EAGLE MOUNTAIN
PLANNING COMMISSION MEETING

EAGLE MOUNTAIN CITY **PLANNING COMMISSION MEETING** **FEBRUARY 27, 2024**
TITLE:	DISCUSSION - Lower Hidden Valley
ITEM TYPE:	Discussion
APPLICANT:	Perry Homes

BACKGROUND:
Perry Homes has submitted a concept plan for some proposed changes to the Lower Hidden Valley plan area. Staff has given Perry comments on the plan. Perry would like the Planning Commission's feedback, as well.

RBallif 1/30/24 no comment at this time
DDeVoogd/UFA 1/30/2024 - No Comment
Todd Black comments
Robert Hobbs comments 2/8/24
SMumford 2/8/24 comments

THE TRAILS AT HIDDEN VALLEY *master plan*

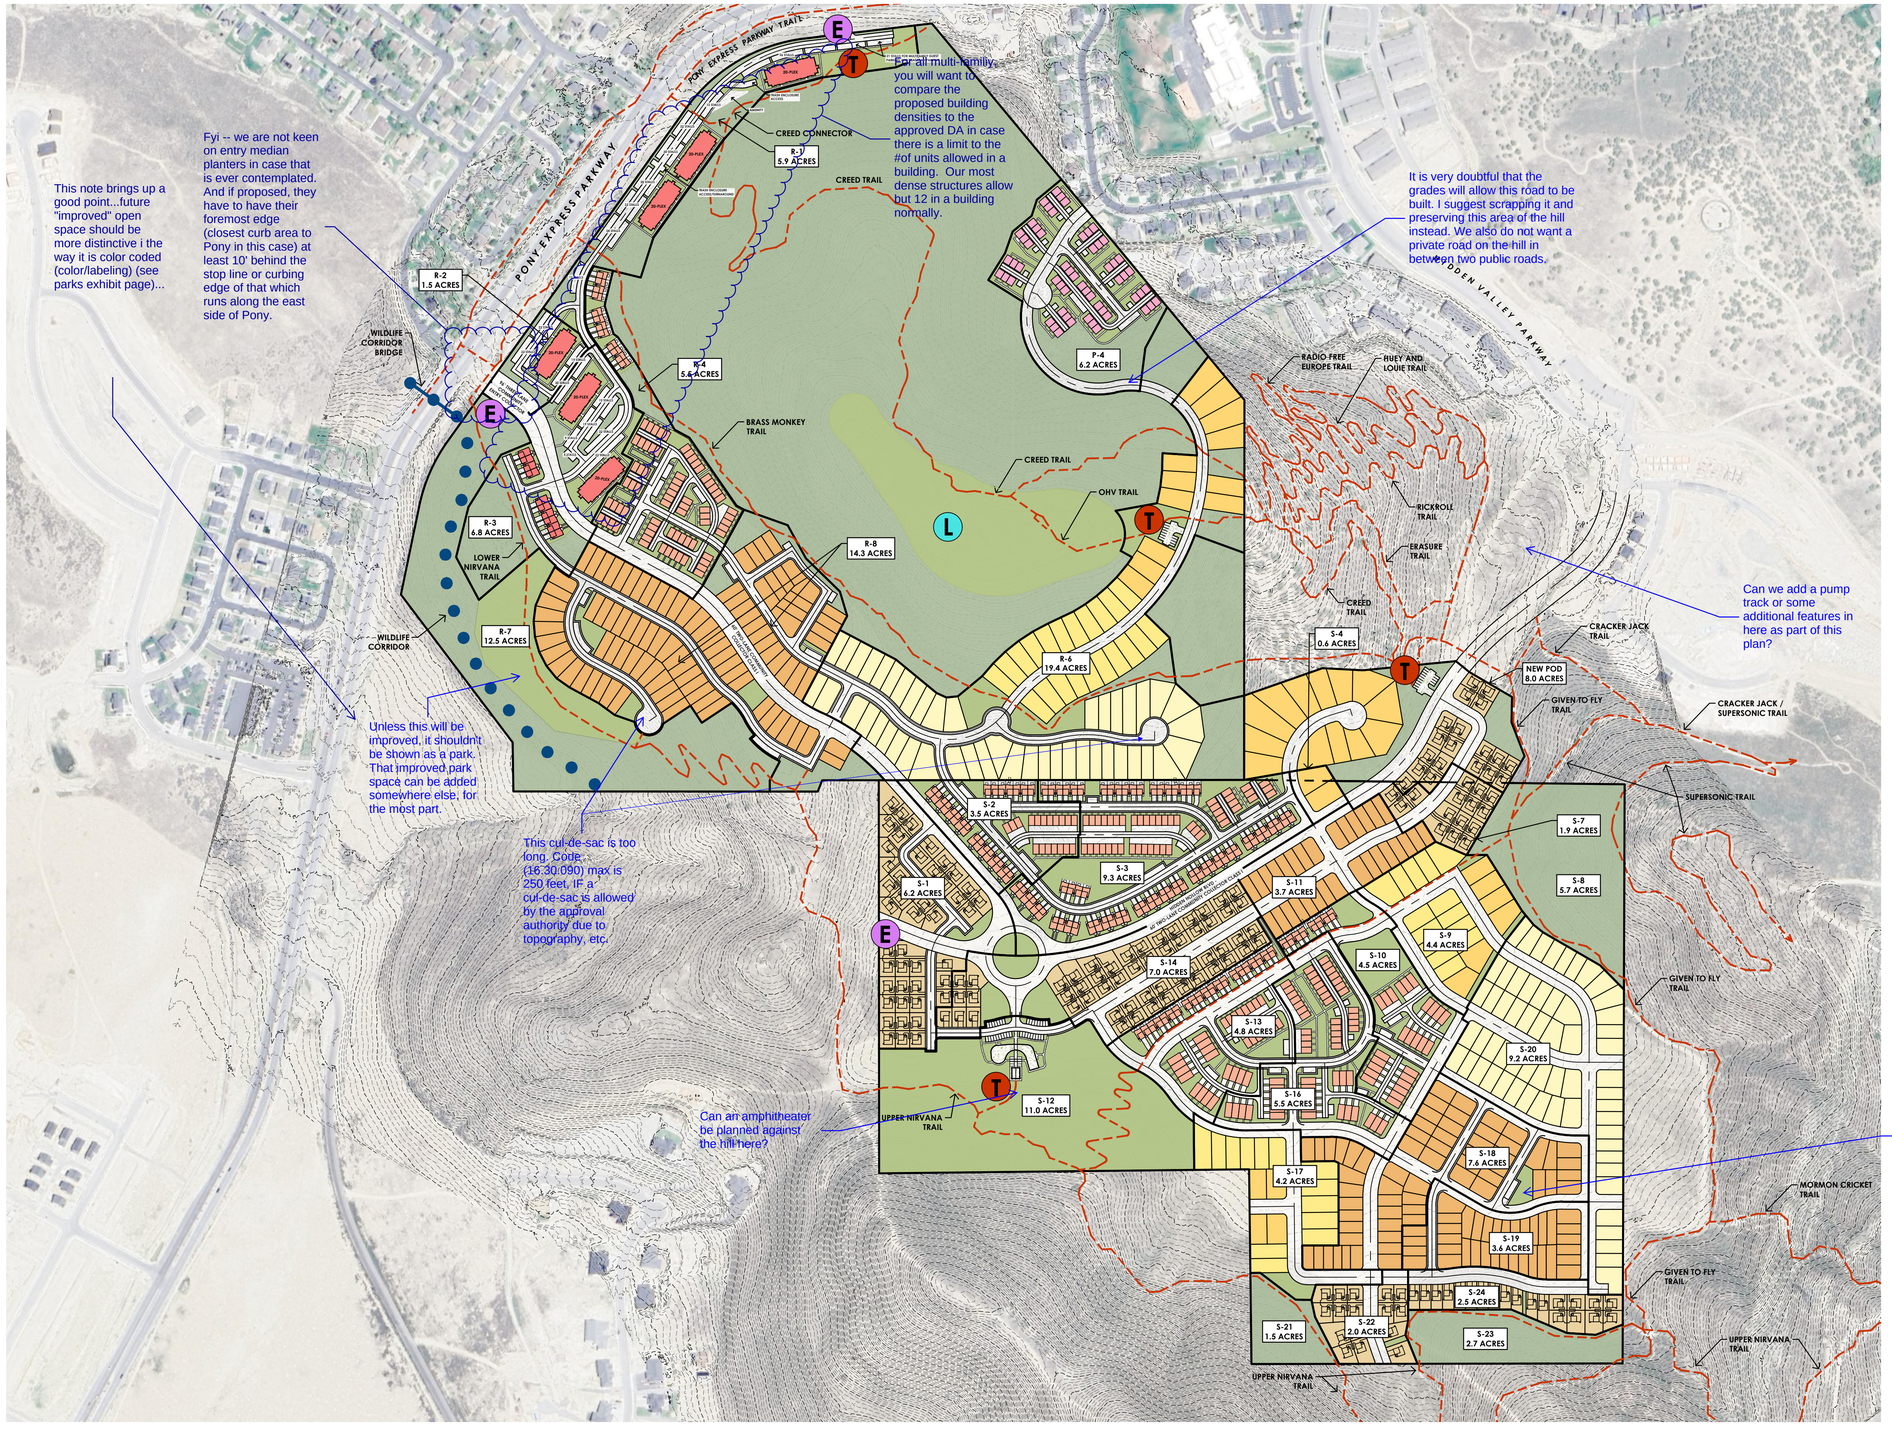
Fyi -- we are not keen on entry median planters in case that is ever contemplated. And if proposed, they have to have their foremost edge (closest curb area to Pony in this case) at least 10' behind the stop line or curbing edge of that which runs along the east side of Pony.

This note brings up a good point...future "improved" open space should be more distinctive i the way it is color coded (color/labeling) (see parks exhibit page)...

Can we add a pump track or some additional features in here as part of this plan?

Unless this will be improved, it shouldn't be shown as a park. That improved park space can be added somewhere else, for the most part.

Can an amphitheater be planned against the hill here?
